Highway Safety Report

Proposed Digital Advertising Scheme at Deansgate Interchange Junction, Manchester

17 January 2024

Appendix A Stage 1 Road Safety Audit and Designer's Response

APPENDIX A: LOCATION PLAN

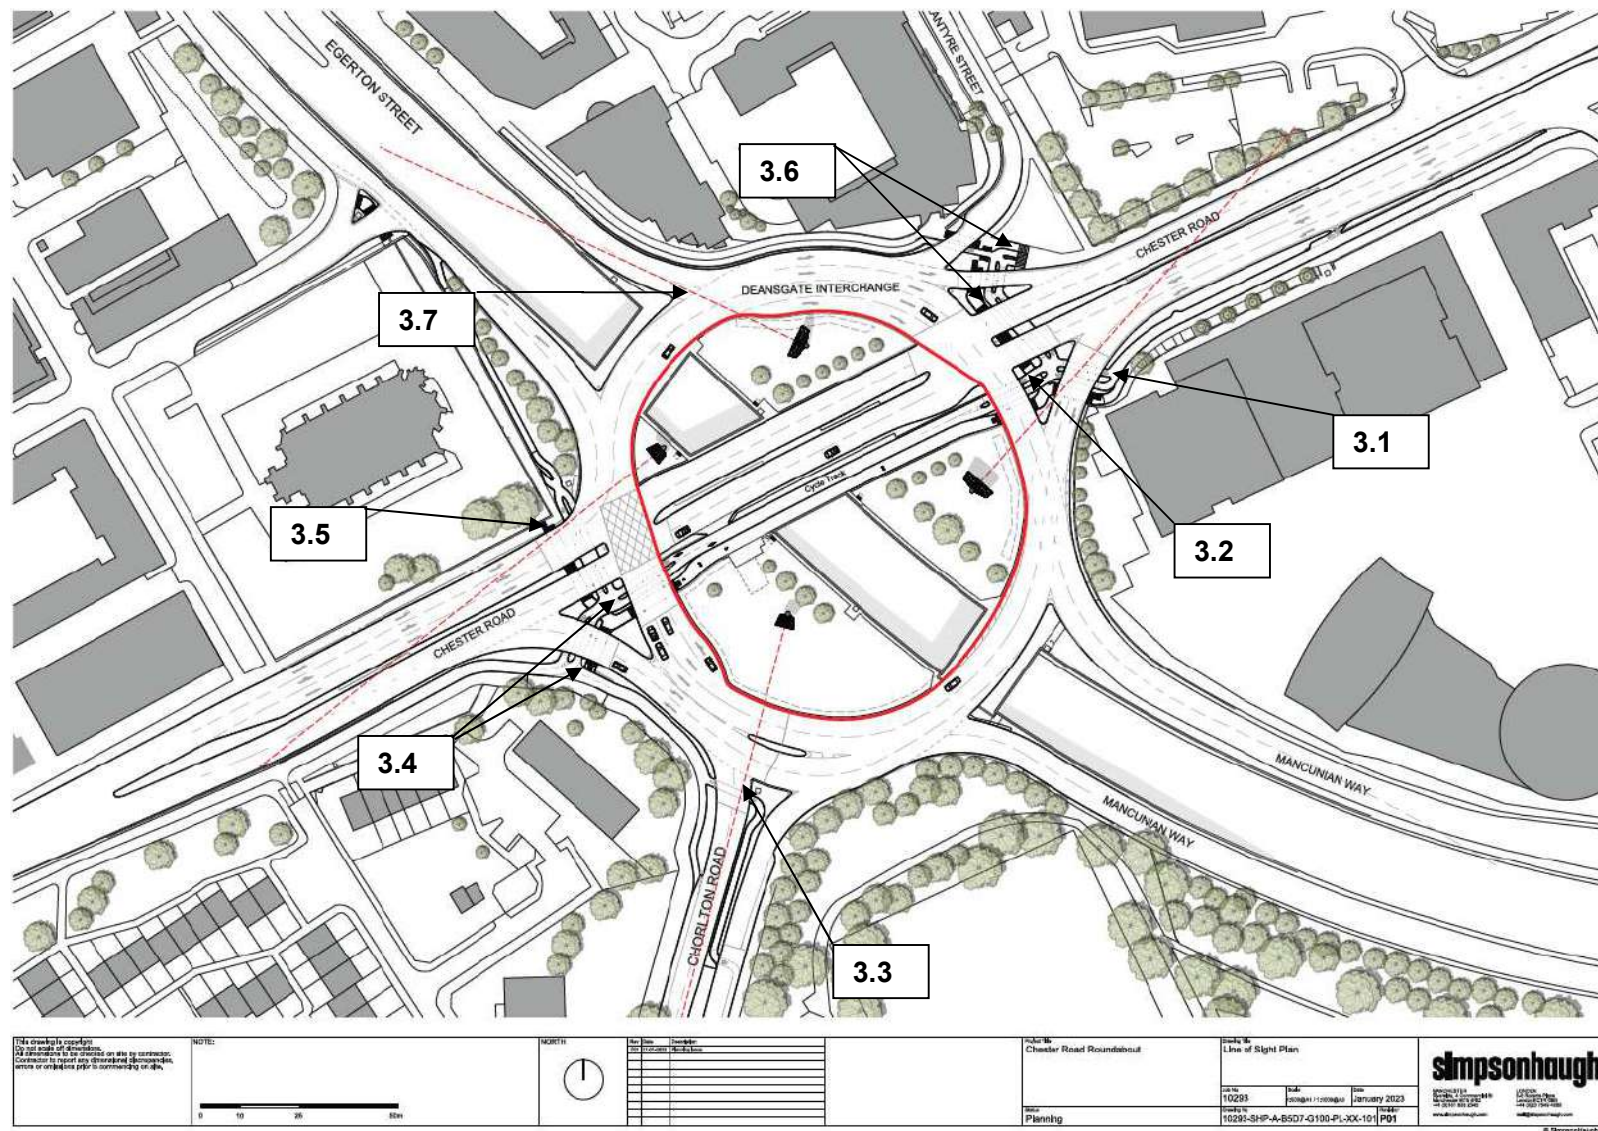
The position of the digital advertising board on the northern quadrant of the roundabout is proposed to be placed so that it can be seen along the length of the A57 off-slip on the SE bound approach to roundabout. There appears to be some history of shunt type collisions occurring along this slip road. The RSA Team are concerned that the digital advertising board could add extra cognitive load onto vehicle drivers who are also negotiating weaving or exiting movements, queueing traffic, and give-way / stop start movements. This could increase the risk of shunt type collision occurring along the length of the slip road.

Problem Identified Ref.	Problem Identified Description / Recommendation	Designers Response (Describe)
3.1	PROBLEM Chester Road SW bound approach to signals at roundabout. Nearside traffic signal head will be in front of digital advertising board on approach. Could result in failure to heed traffic signals. It was noted that a SW bound vehicle on Chester Road approaching the roundabout and traffic signals will line up with the nearside traffic signal head and the proposed digital advertising board. It is thought that the relative locations of the board as well as the mounting height of board will mean that the traffic signal head will be in front of the digital advertising board for traffic in all lanes at some point on the approach, and for traffic in the left turn lane and lane one for an extended period. When the traffic signal is in front of the digital advertising board it will be more difficult to see properly and hence may not be correctly heeded. The offside traffic signal heads could be masked by high sided vehicles and the traffic in the left turn nearside lane could fail to heed a red signal and enter the roundabout circulatory carriageway in conflict with other traffic or collide with a crossing user. RECOMMENDATION The position and height of the digital advertising board should be such that it is not placed directly behind the traffic signals at any point on the near approach to the junction so that it might distract from the traffic signals, crossing, or movements at the junction.	The driver sightline towards the proposal site (Location D digital advertising display) at the 43m Stopping Sight Distance (SSD) on the A56 Chester Road east approach to the stop lines (critical decision-making distance) has been reviewed in detail. As shown in Drawing VN232785-D100 Rev C, it is considered that the proposed advertising display position and the locations of the nearside and offside traffic signals that control this arm of the Deansgate Interchange junction will not interact in respect of approaching drivers at the 43m SSD for the 30mph approach speed, and there will be no safety conflict.

Problem Identified Ref.	Problem Identified Description / Recommendation	Designers Response (Describe)
3.2	PROBLEM SW bound cycle crossing. Refuge island between Chester Road ahead and left turn lanes on approach to roundabout. Possible see through to digital advertising board for cycles past cycle aspect signal head. A cyclist waiting to cross the circulatory carriageway in the refuge island between Chester Road ahead and left turn lanes on the approach to roundabout may have their nearside cycle signal aspect in front of the digital advertising board on the eastern quadrant of the roundabout central island. This could result in a cyclist failing to interpret or read the signal correctly and entering the carriageway into the path of traffic. RECOMMENDATION Position the advertising board or signal aspect such that the board is not directly behind the cycle signal aspect when a cyclist is approaching it or waiting to cross. Should this not be possible then backing boards around the aspect may be beneficial.	The proposal site (Location D digital advertising display) is positioned to the south of the nearside cycle signal aspect at this location. The height of the cycle signal will be below the digital advertising screen, which is raised approximately 3.2m above ground level, and so there will be no interaction or safety conflict. In addition, the bicycle signal heads at the crossing will be immediately adjacent to a cyclist waiting to cross, and the digital advertising display will not be in this visibility envelope.

Problem Identified Ref.	Problem Identified Description / Recommendation	Designers Response (Describe)
3.4	PROBLEM Crossings over circulatory carriageway, and the exit lanes from roundabout onto Chester Road SW bound. Possible to see through to digital advertising board for cycles and pedestrians past cycle / pedestrian signal aspects. Pedestrians and cycles crossing NE bound from Chester Road over the circulatory carriageway and the SW bound exit lanes from the roundabout onto Chester Road may have their cycle or pedestrian signal aspect in front of the digital advertising board on the southern quadrant of the roundabout central island. This could result in a cyclist or pedestrian failing to interpret or read the signal correctly and entering the carriageway into the path of traffic. RECOMMENDATION Position the advertising board or signal aspects such that the board is not directly behind the signal aspects when a cyclist or pedestrian is approaching it or waiting to cross. Should this not be possible then backing boards around the aspect may be beneficial.	The proposal site (Location C digital advertising display) is positioned to the southeast of the pedestrian and cycle signal aspects at this location, and the advertising screen will be angled in a southwest direction away from these signal aspects. The height of the pedestrian and cycle signals will be below the digital advertising screen, which is raised approximately 3.2m above ground level, and so there will be no interaction or safety conflict. The bicycle signal heads at the crossing will be immediately adjacent to a cyclist waiting to cross, and the digital advertising display will not be in this visibility envelope. In addition, the proposed digital display will be enclosed by a cowl design and setback within the hood, and this will minimise the interaction of the advertising screen with these signal aspects.

Problem Identified Ref.	Problem Identified Description / Recommendation	Designers Response (Describe)
3.6	PROBLEM Crossing over Chester Road from north to south. Possible see through to digital advertising board for cycles and pedestrians past cycle / pedestrian signal aspects. Pedestrians and cycles crossing Chester Road north to south may have their cycle or pedestrian signal aspect in front of the digital advertising board on the eastern quadrant of the roundabout central island. The locations where this is of concern are on the northern kerb line, and within the island between the roundabout circulatory carriageway exit and Chester St through carriageway. This could result in a cyclist or pedestrian failing to interpret or read the signal correctly and entering the carriageway into the path of traffic. RECOMMENDATION Position the advertising board or signal aspect such that the board is not directly behind the cycle signal aspect when a cyclist is approaching it or waiting to cross. Should this not be possible then backing boards around the aspect may be beneficial.	The proposal site (Location D digital advertising display) is positioned to the south of the pedestrian and cycle signal aspects at this location, and the advertising screen will be angled in an eastern direction away from these signal aspects. The height of the pedestrian and cycle signals will be below the digital advertising screen, which is raised approximately 3.2m above ground level, and so there will be no interaction or safety conflict. The bicycle signal heads at the crossing will be immediately adjacent to a cyclist waiting to cross, and the digital advertising display will not be in this visibility envelope. In addition, the proposed digital display will be enclosed by a cowl design and setback within the hood, and this will minimise the interaction of the advertising screen with these signal aspects.

3.7	PROBLEM A57 off-slip SE bound approach to roundabout. Possible distraction caused by digital advertising board that could increase risk of shunt type collisions. The position of the digital advertising board on the northern quadrant of the roundabout is proposed to be placed so that it can be seen along the length of the A57 off-slip on the SE bound approach to roundabout. There appears to be some history of shunt type collisions occurring along this slip road. The RSA Team are concerned that the digital advertising board could add extra cognitive load onto vehicle drivers who are also negotiating weaving or exiting movements, queueing traffic, and give-way / stop start movements. This could increase the risk of shunt type collision occurring along the length of the slip road. RECOMMENDATION Position the digital advertising board such that it does not align directly with the off-slip road.	Due to the relatively straight alignment of the carriageway towards the proposal site, it is considered that drivers will have good visibility and a clear sight line towards the advertising display position from around 150m to the north. This is an appropriate forward visibility distance for the speed of the road, which would give sufficient time for the proposal's contents to be assimilated without surprise. Drivers on the approach to the give way line at the entry to the roundabout will be aware of the of the digital display in advance of the junction and given its location in the driver's eye line, the advertising screen will be visible in the same view as drivers looking ahead. Vehicles exiting the priority junction will be giving way to traffic on the roundabout circulatory that is approaching from the southwest, and the proposed advertising displays at Locations A and B will not conflict with this sightline.
